General Electric Company
175 Gartner Avenue, San Jose, CA 95126

MFN No. 081-92
Docket No. STN 52-001
SLK-9249

Subject: **GE Responses to the Resolution of Issues Related to Chapter 15 of
ABWR DSER SECY-91-355**

Enclosed are thirty-four (34) copies of the GE responses to NRC staff comments and to Outstanding Issues 136 and 139. In addition, the test has been revised to incorporate the response to Outstanding Issue 135 provided in the referenced letter.

Figure 15.1-3 ~~RUNOUT OF TWO FEEDWATER PUMPS~~

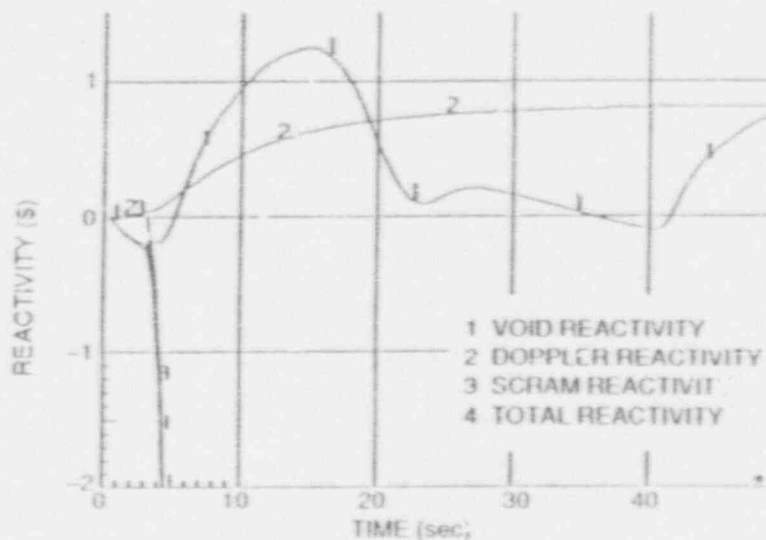
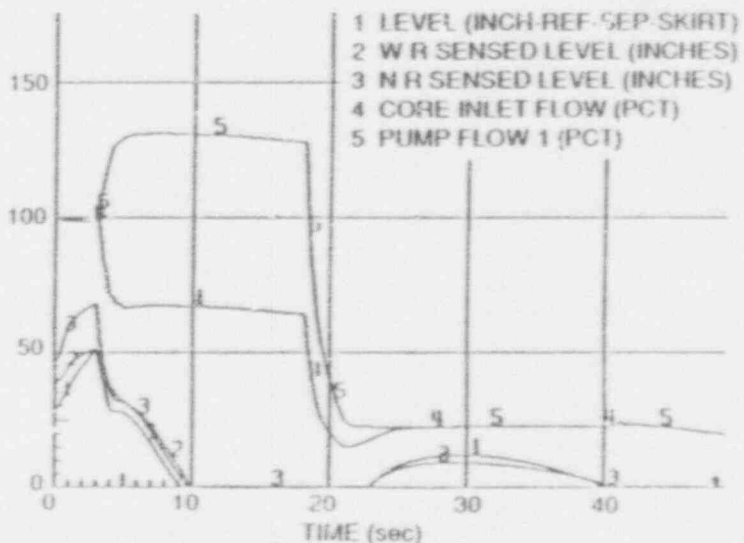
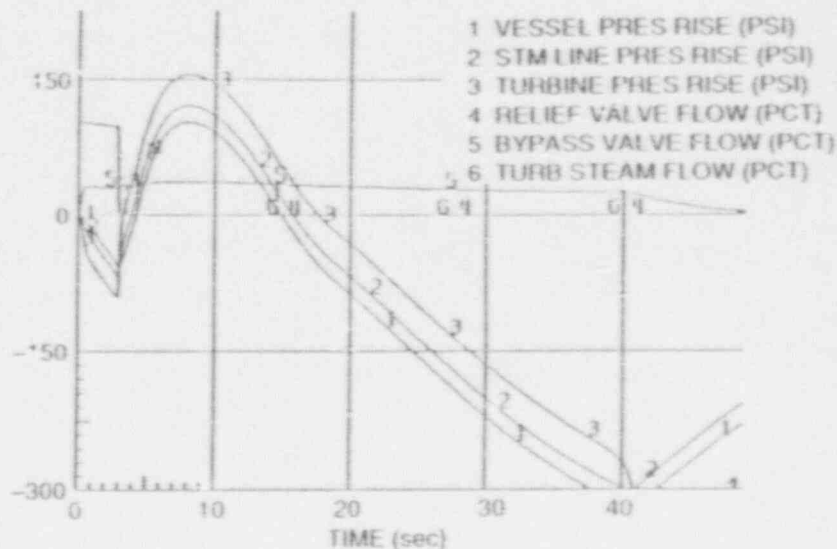
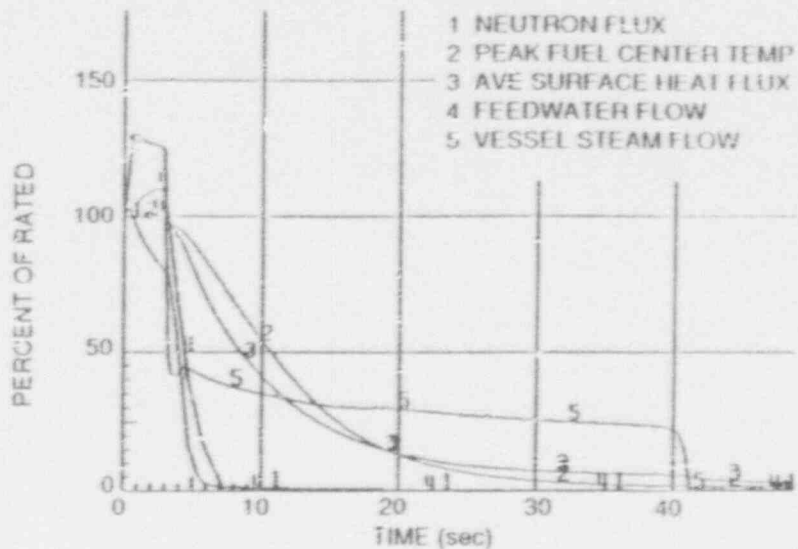
15.1.2.2.1.2 ~~Runout of Two Feedwater Pumps~~ *Feedwater Controller Failure - Maximum Demand*

With excess feedwater flow, the water level rises to the high-level reference point, at which time the feedwater pumps and the main turbine are tripped and a scram is initiated. Table 15.1-5 lists the sequence of events for Figure 15.1-3. The figure shows the changes in important variables during this transient.

The simulated runout of ~~two~~ ^{all} feedwater pumps ~~event~~ is shown in Figure 15.1-3. The high water level turbine trip and feedwater pump trip are initiated at approximately 18 seconds. Scram occurs and limits the neutron flux peak and fuel thermal transient so that no fuel damage occurs. It is calculated that the MCPR is right at the safety limit. Therefore, the design limit for the moderate frequent incident is met. The turbine bypass system opens to limit peak pressure in the steamline near the SRVs to 82.8 kg/cm²g and the pressure at the bottom of the vessel to about 84.9 kg/cm²g.

Feedwater Controller Failure - Maximal Demand

Figure 15.2-1c CLOSURE OF ONE TURBINE CONTROL VALVE

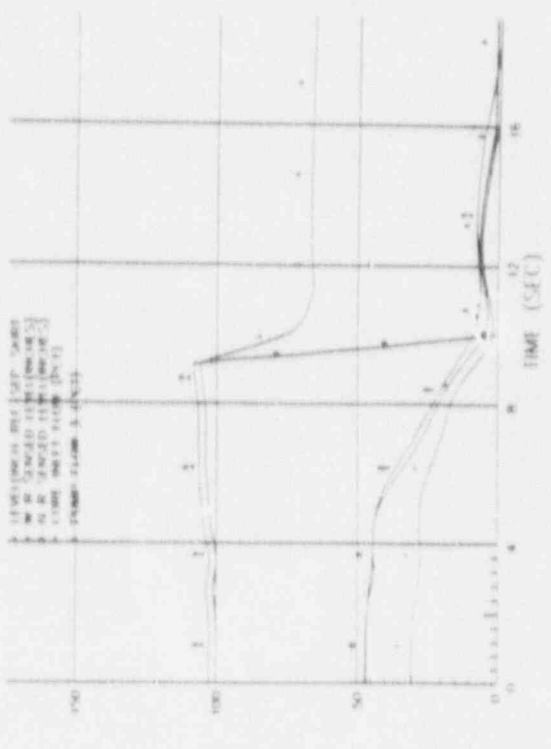
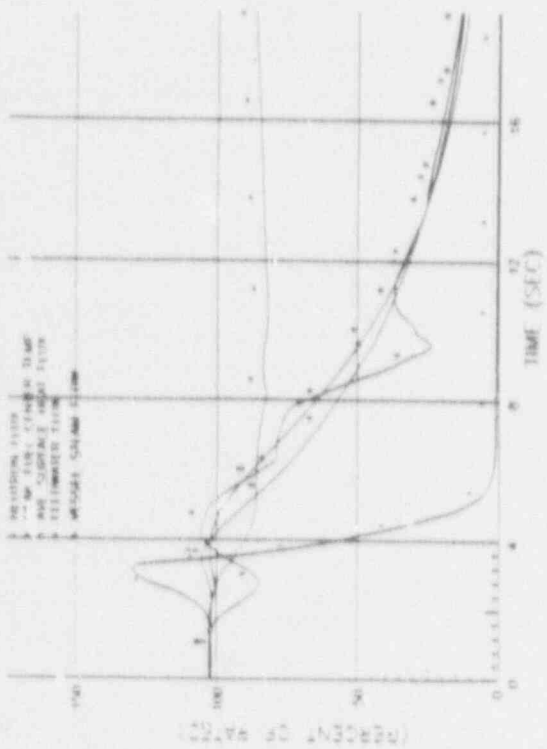
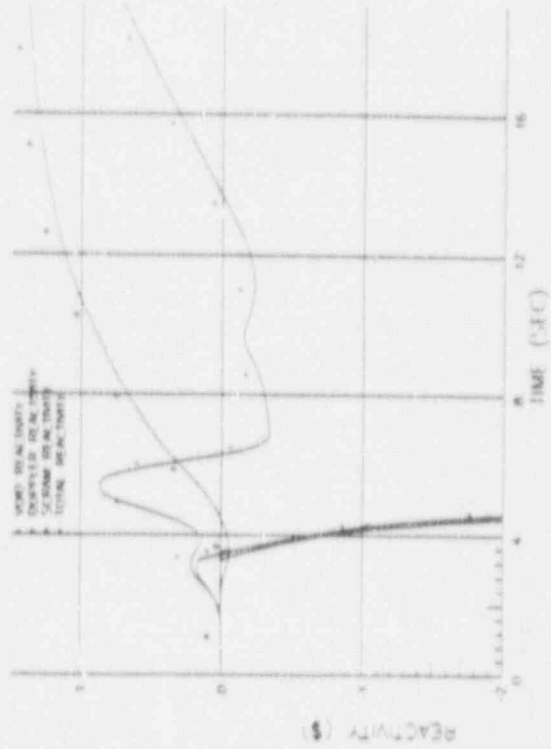
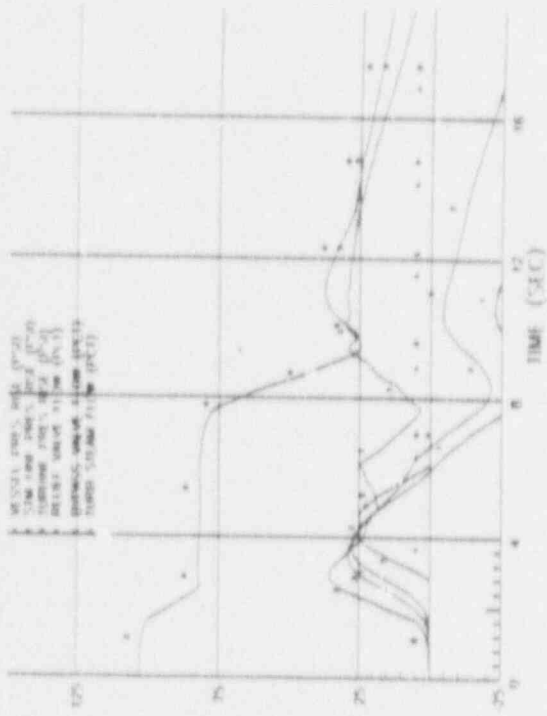
^(2.5 seconds) valve is presented in Figure 15.2-1A. The analysis assumes that about 85% of rated steam flow can pass through the remaining three turbine control valves.

FAST

new figure

Figure 15.2-16 SLOW CLOSURE OF ONE TURBINE CONTROL VALVE

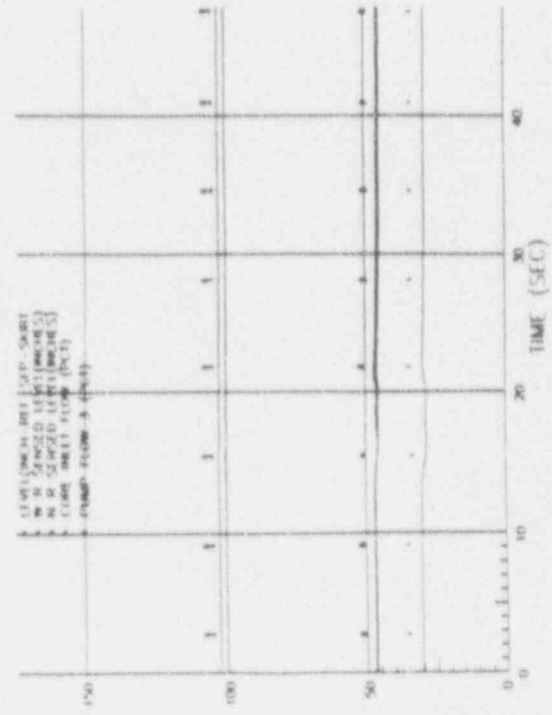
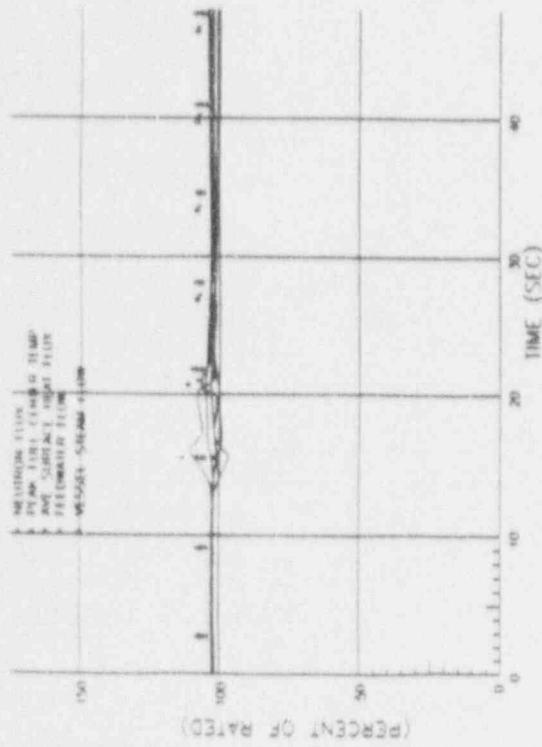
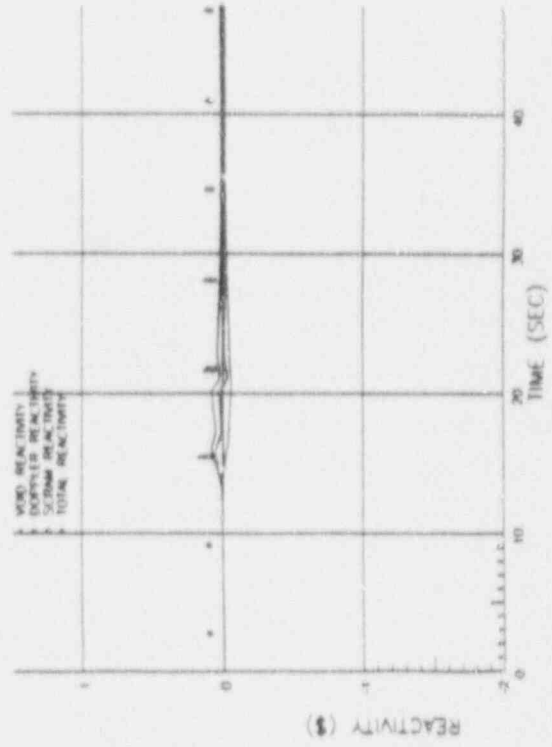
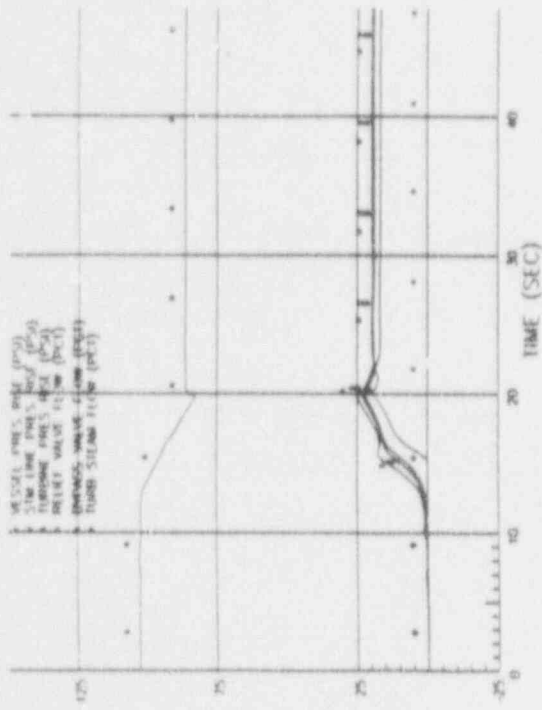
A slow closure of one turbine control valve is also analyzed as shown in Figure 15.2. -1b. In this case, the neutron flux increase does not reach the high neutron flux alarm setpoint. Since the available turbine bypass capacity is high enough to bypass all steam flow not passing through remaining three turbine control valves, the reactor power settles back its steady state. During the transient, the peak fuel surface heat flux does not exceed 103.6% of its initial value. MCPA is still above the safety limit ($\Delta CPA = 0.09$). Therefore, the design basis is satisfied.

Figure 15.3-2a cladding Temperature during
All pump Trip

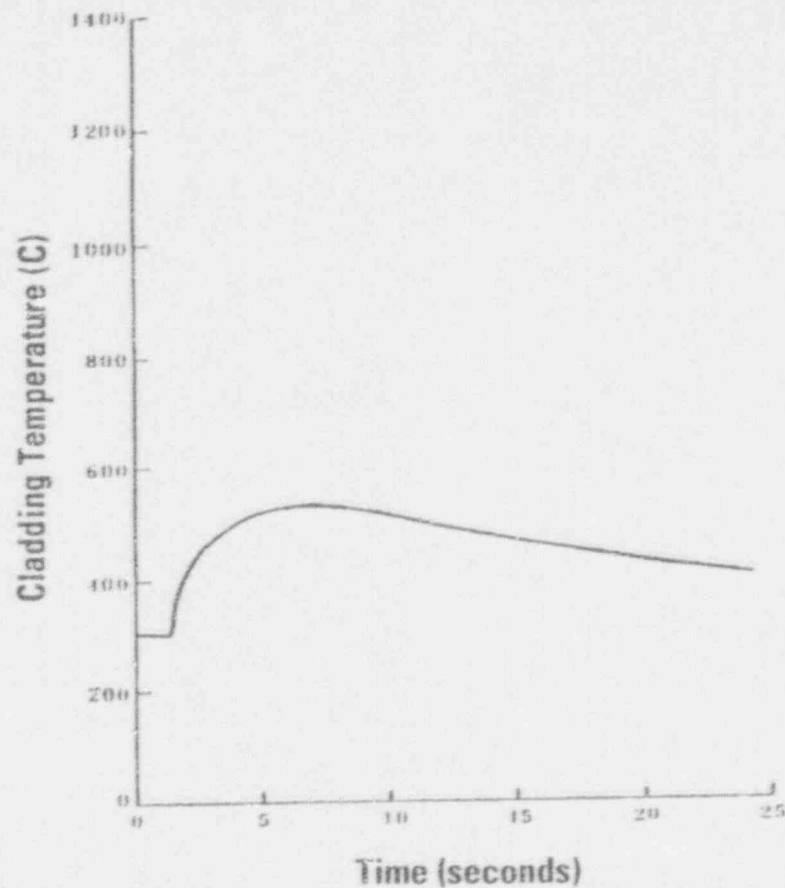
The cladding temperature during this event is shown in Figure 15.3-2a. Since the time that the cladding temperature is above the coolant saturated temperature is less than 60 seconds, and the peak cladding temperature is less than 600°C , no fuel failure is expected.
